Ref: 740.DA5.320.002

RESPONSE TO INFORMATION REQUEST LETTER

DEVELOPMENT APPLICATION FOR A MATERIAL CHANGE OF USE – DEVELOPMENT PERMIT FOR EXTRACTIVE INDUSTRY AT THE EXISTING BROMELTON NORTH QUARRY ON LAND SITUATED OFF SANDY CREEK ROAD, BROMELTON, QLD 4285, PROPERLY DESCRIBED AS LOT 1 ON RP98576

OFFICE OF COORDINATOR GENERAL REFERENCE: AP2022/022

Approved and Proposed Development

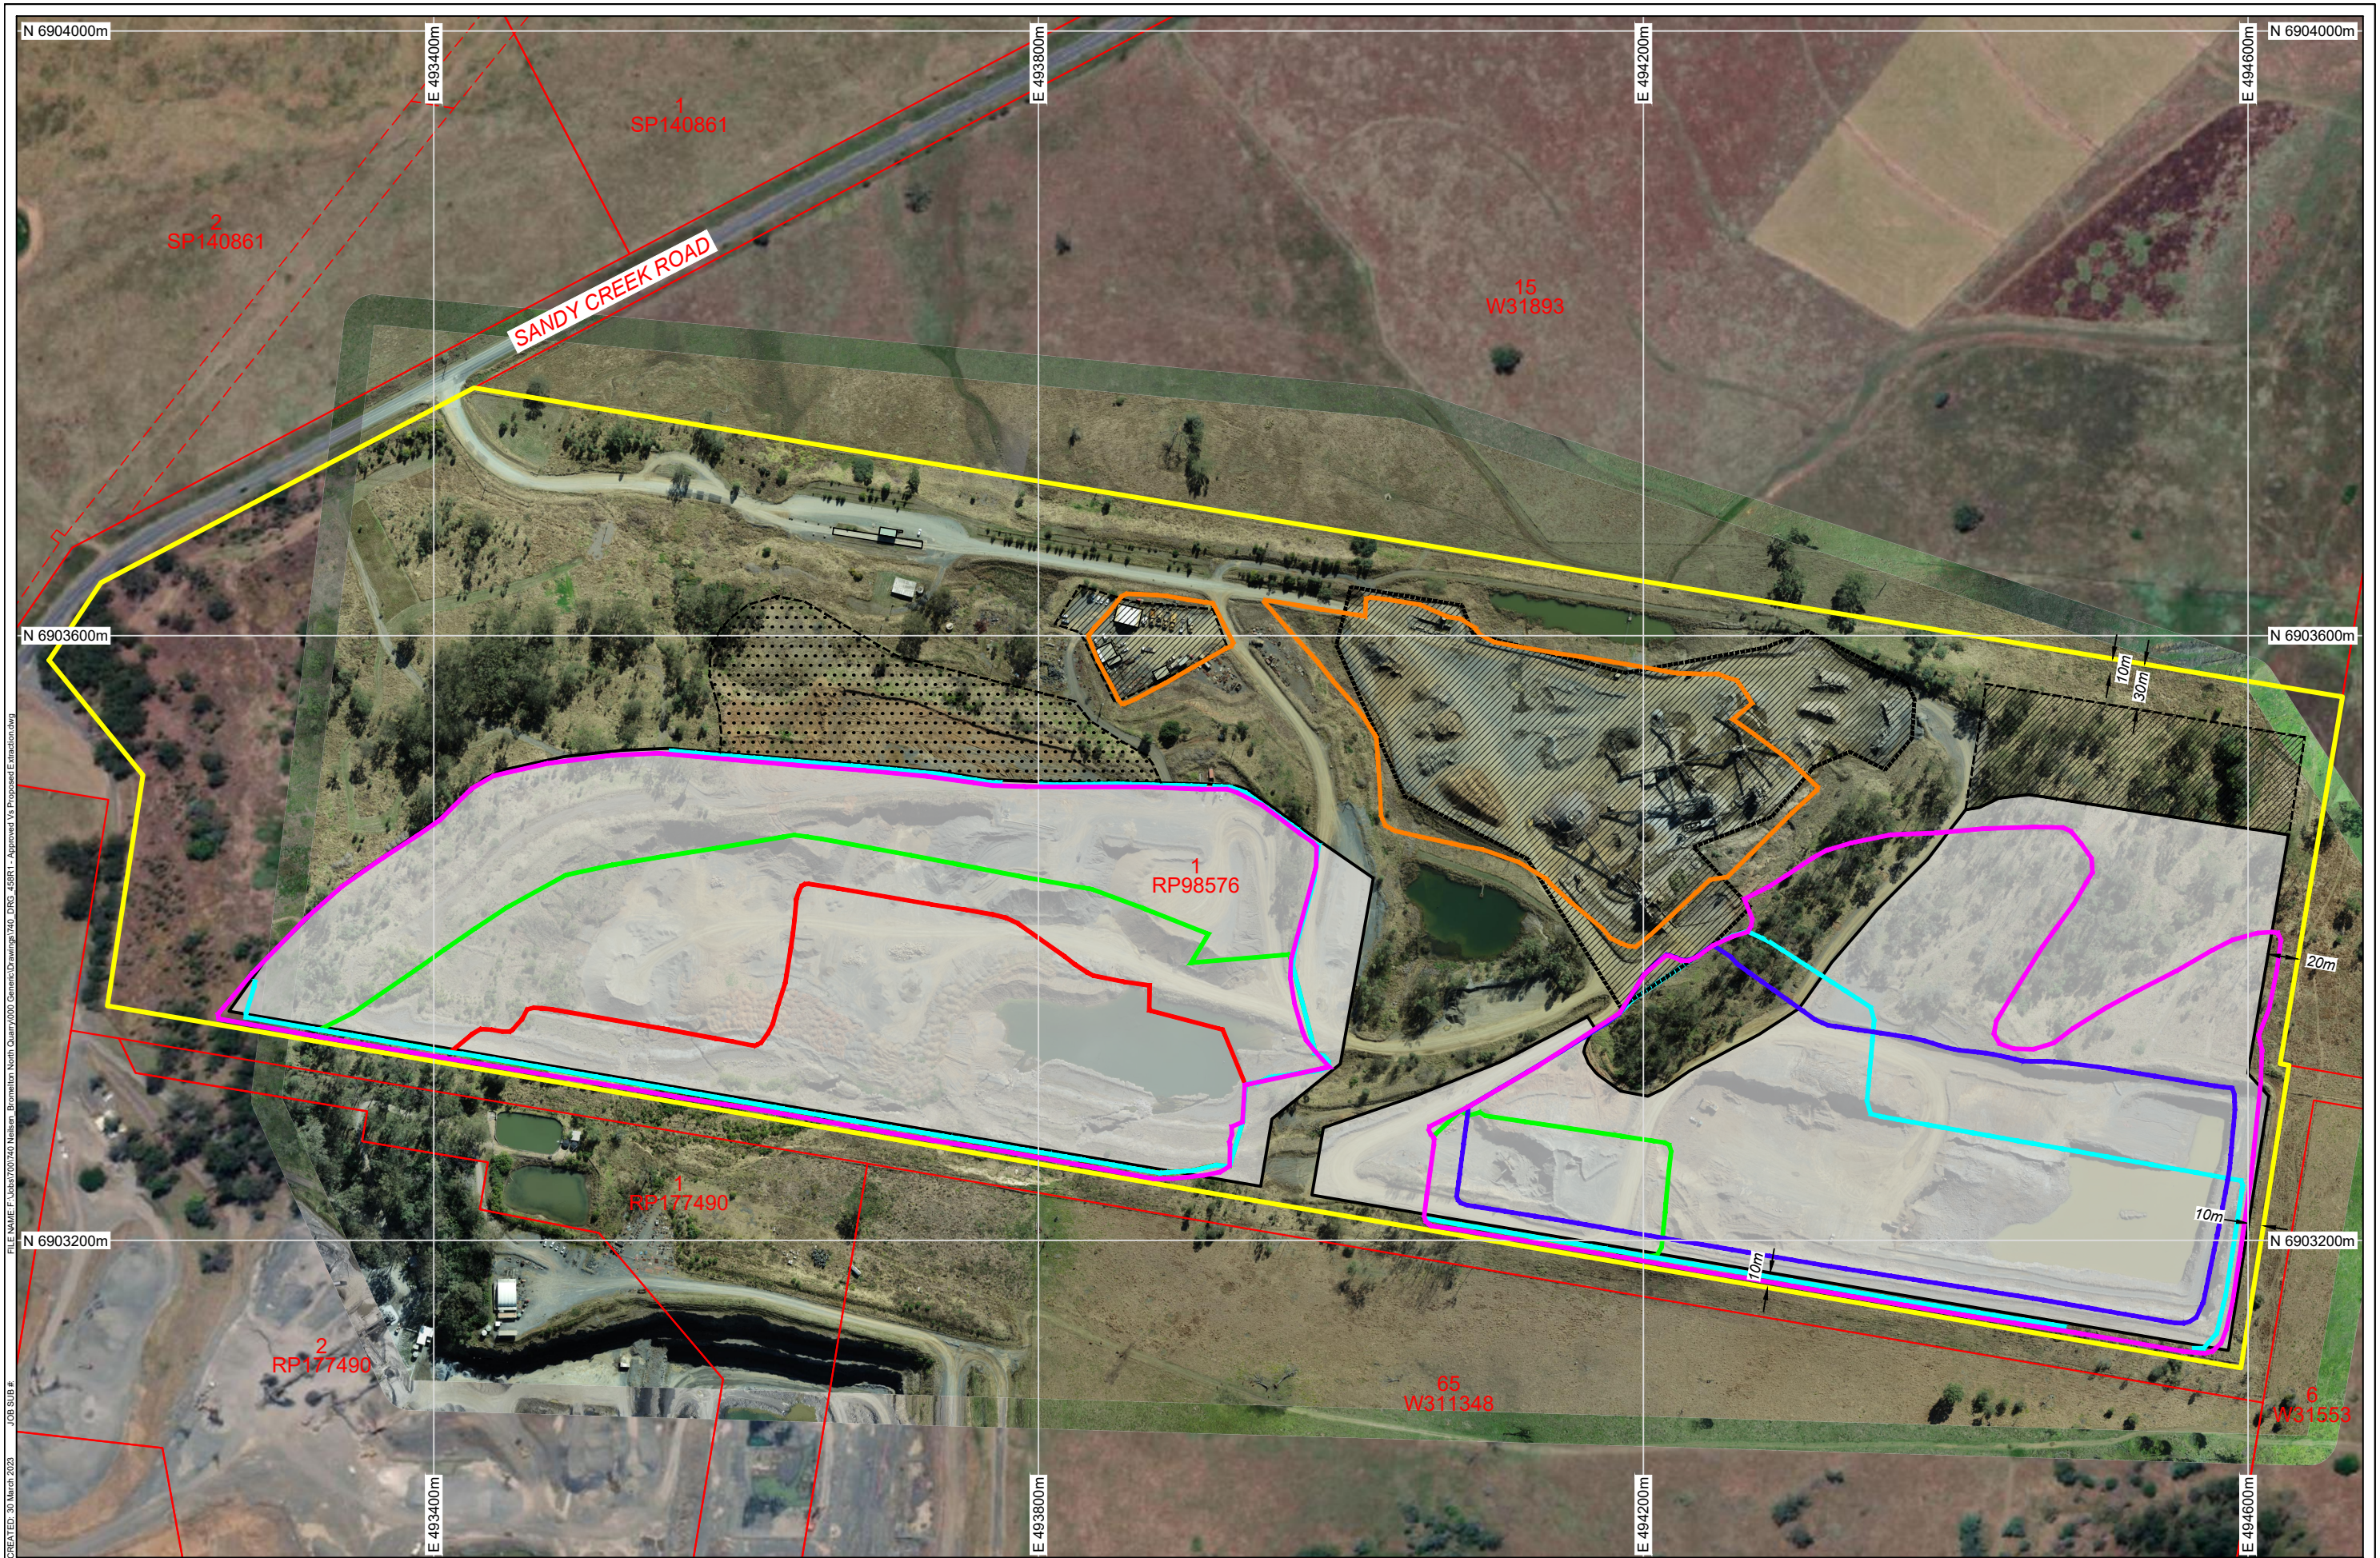
The Bromelton North Quarry is currently operating pursuant to Consent Order for Material Change of Use – Development Permit for Extractive Industry (reference 3448 of 2003) granted on 23 June 2004. The Consent Order allows for the extraction of 400,000 tonnes per annum of material in stages and states other conditions to be complied with. A thorough understanding of the current status of site operations and compliance with the Consent Order is required in order to assess the SDA application.

Item 3 (1) The proponent is requested to provide additional details regarding the current status of the Consent Order and the associated conditions, including:

- a) details of activity of each stage and current status*
- b) details and evidence of the conditions under the Consent Order that have been complied with*
- c) details and evidence of the conditions under the Consent Order that are yet to be complied with (i.e., not finalised)*
- d) details and evidence of any rehabilitation undertaken on the site in accordance with the conditions under the Consent Order*
- e) in regard to road upgrades, details and evidence of:*
 - i) any upgrades of Sandy Creek Road as a result of the Consent Order*
 - ii) any upgrades to the intersection of Sandy Creek Road with Beaudesert-Boonah Road, including any approval issued by the Department of Transport and Main Roads.*

- The West Pit and East Pit have developed generally in accordance with the approved quarry footprint;
- The stockpile and plant area extends beyond the approved area;
- The office/workshop/staff parking area extends beyond the approved area;

- Approved Plans (Condition ii): A plan has been prepared to visually represent the extent of approved and current operations (refer **Appendix B – Approved and Proposed Development**).

As requested by Item 3(1)(a) and 5(1)(d), a plan showing the current approved operation compared to the proposed development has been prepared (refer **Appendix B – Approved and Proposed Development**).

Site Layout Plan

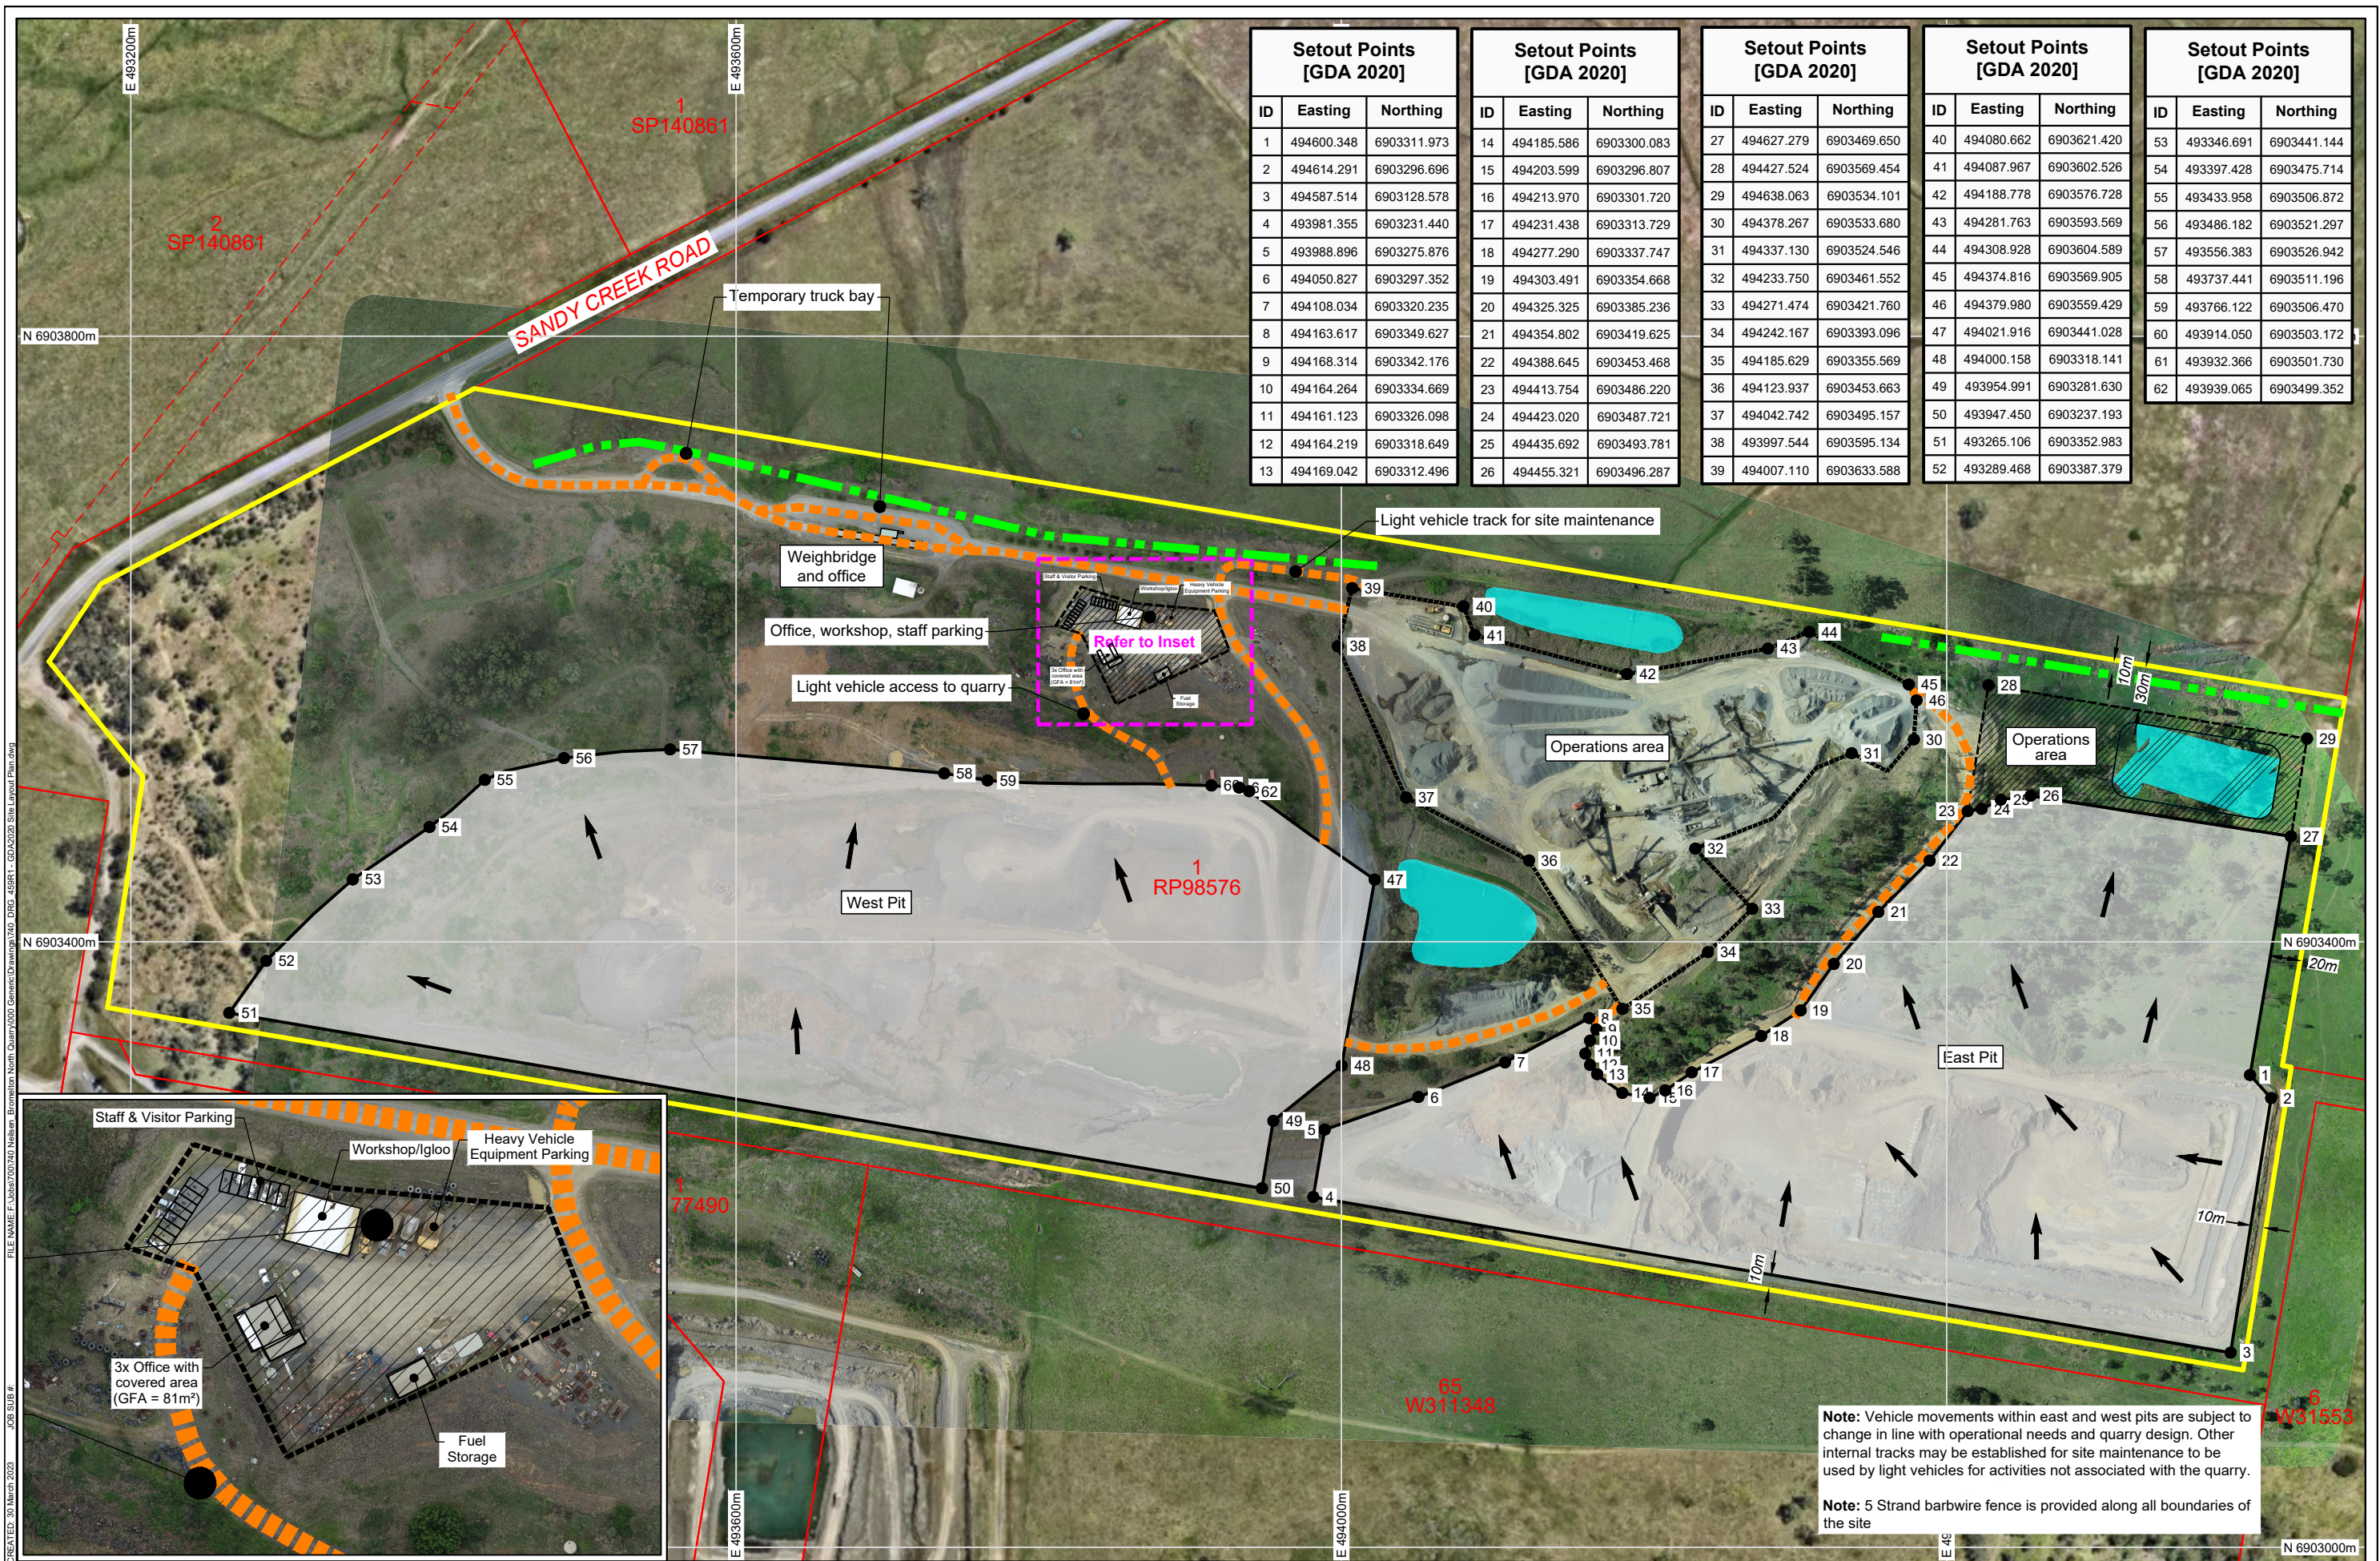
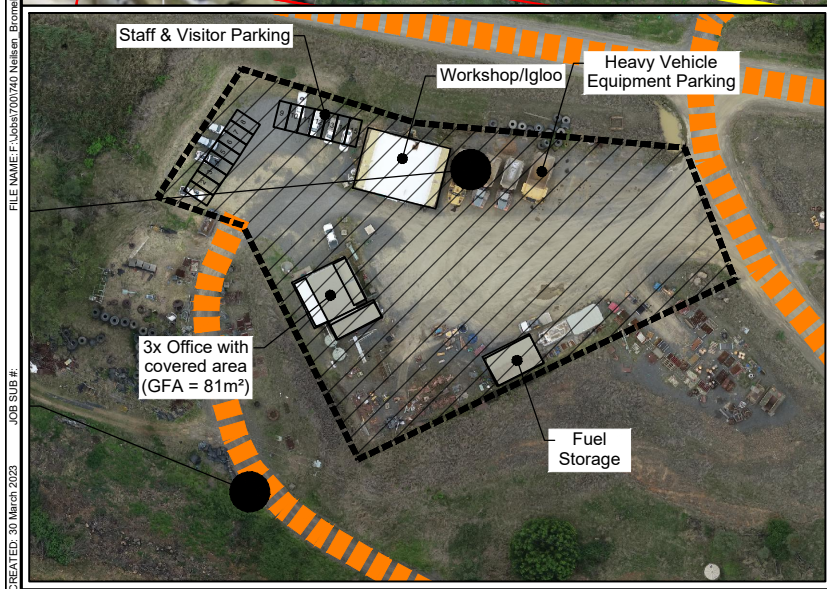
Item 4 (1) The proponent is requested to:

- a) confirm whether the existing internal light vehicle access roads and haul roads are to be retained and/or realigned with the operational changes.

Item 5(1) The proponent is requested to submit updated plans to include the following to provide greater clarity and more details including:

- a) clearly identify facilities and infrastructure that will be retained and/or any new proposed infrastructure including
 - i) site offices and amenities block, truck parking areas
 - ii) car parking for staff and visitors

- iii) *weighbridge, workshop and truck wash down facility*
- iv) *security fencing*
- v) *existing and new onsite plant and equipment (if proposed).*
- b) *provide general sequence of extraction for the current operations (including previous extraction) and future extension*
- c) *identify any changes to internal haul routes (if any and as requested above)*
- d) *provide a plan showing current operations (as approved under Consent Order - reference 3448 of 2003) over the whole subject site compared to the proposed operations subject of this SDA application.*

The site layout plan has been amended to clarify the extent of long-term internal access routes and maintenance tracks (refer **Appendix C – Site Layout Plan**).

An amended site layout plan has been prepared (refer **Appendix C – Site Layout Plan**). As discussed in response to Item 3, there are aspects of the site development which differ from that currently approved. The current extent of operations areas, buildings and infrastructure on site is not intended to change.

The Site Layout Plan identifies:

- location of car parking for staff and visitors;
- location of weighbridge and workshop (in the form of an igloo);
- a 1.5m high barb-wire fence is provided along all boundaries of the site. This has been sufficient to manage unwanted access to the site since commencement of the operation;

- The fixed plant will remain within the central operations area. As detailed in section 3.1 of the Planning Assessment Report, the increased output will be achieved through the efficient use of onsite plant and equipment within the existing hours of operation. The Noise and Air Quality Assessments undertook an assessment of the proposed development, including maximum extraction rate and activities occurring across the site (refer **Attachment 8** and **Attachment 9** of the Planning Assessment Report).

- arrows have been included to demonstrate the sequence of extraction; and
- permanent internal access roads have been clarified. As mentioned above in response to Item 4, vehicle routes within the pit are subject to change during the course of extraction activities and are therefore not shown on the site layout plan.

A vegetation buffer is proposed along the northern boundary, as shown on the site layout plan (refer **Appendix C – Site Layout Plan**). The purpose of this vegetation buffer is to minimise and soften the visual appearance of the proposed development from surrounding properties and vehicles travelling on Sandy Creek Road.
